**SUNDRY NOTICES AND REPORTS ON WELLS**  
*Do not use this form for proposals to drill or to re-enter an abandoned well. Use form 3160-3 (APD) for such proposals.*

8. Well Name and No.  
POKER LAKE UNIT 364H

BOPCO, L.P. respectfully requests to ammend the pressure control section and choke manifold schematic as attached.

**Latshaw 13-5/8" or 11" X 3-M BOPE (2 Rams and Rotating Head) & Closed Loop System Equipment Schematic Diagram C**

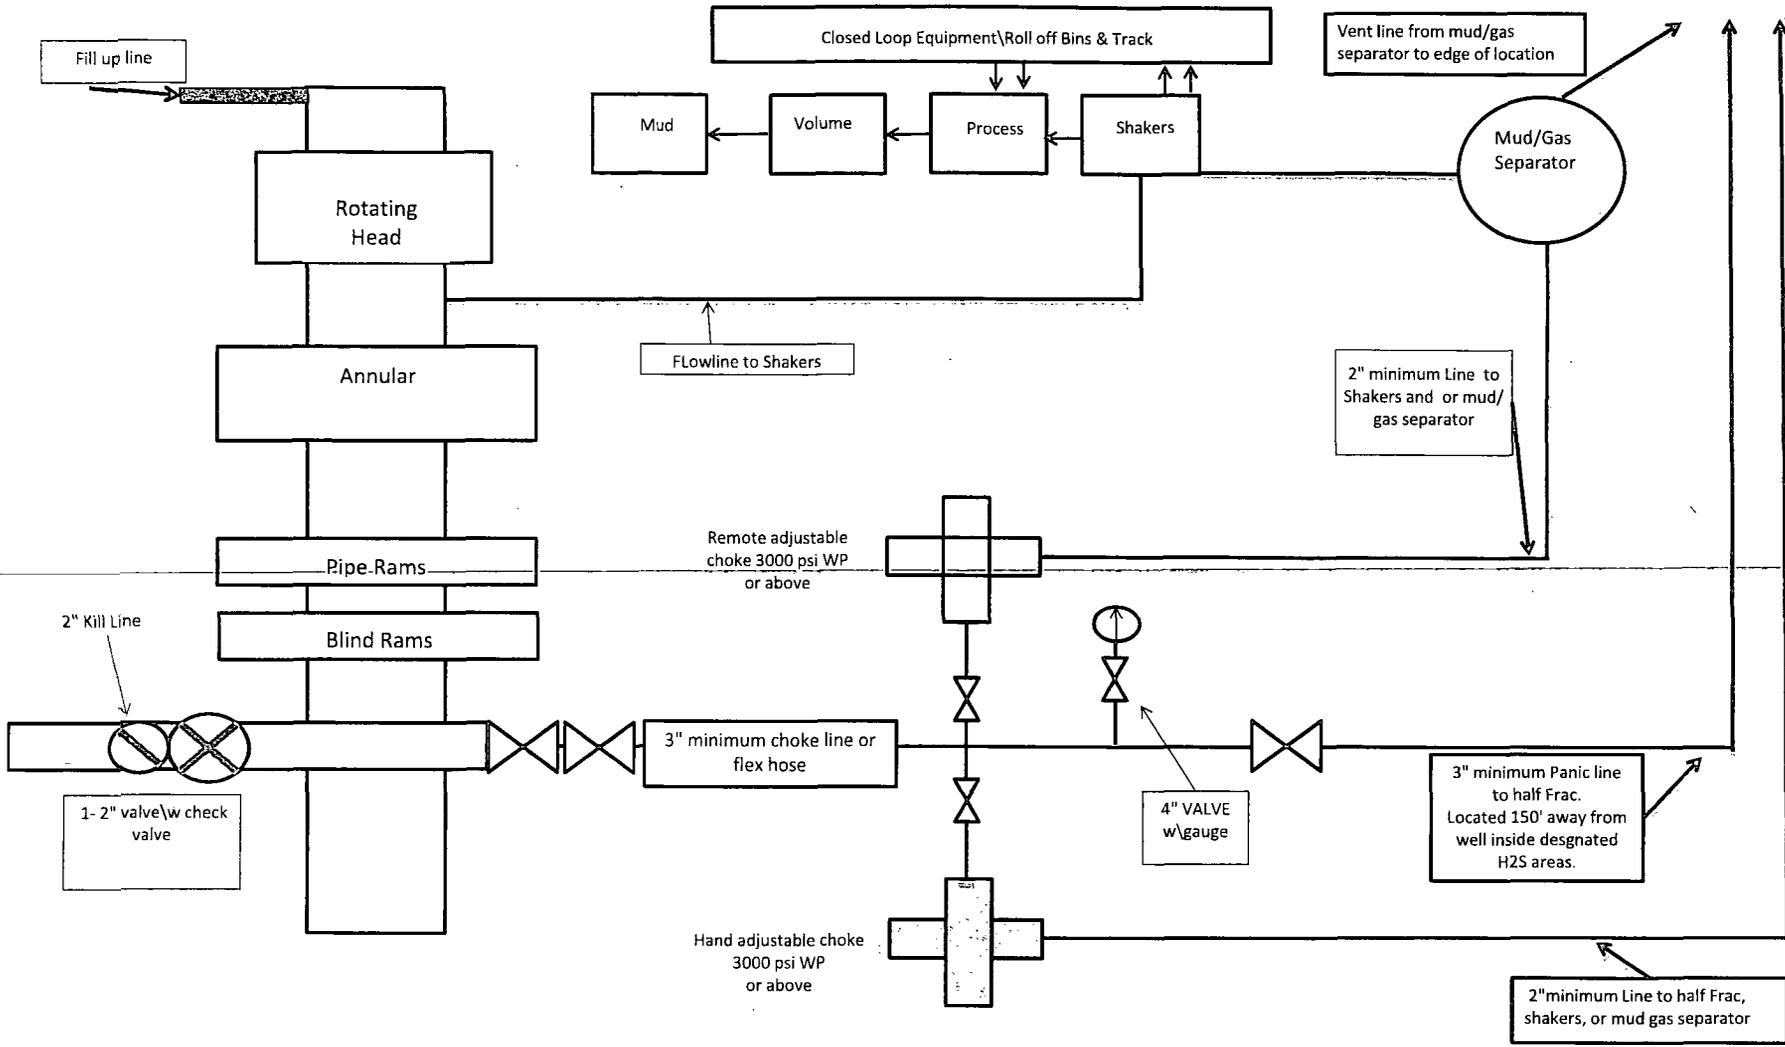
Latshaw 4 closed loop system, with Latshaw 18 addition "clouded."
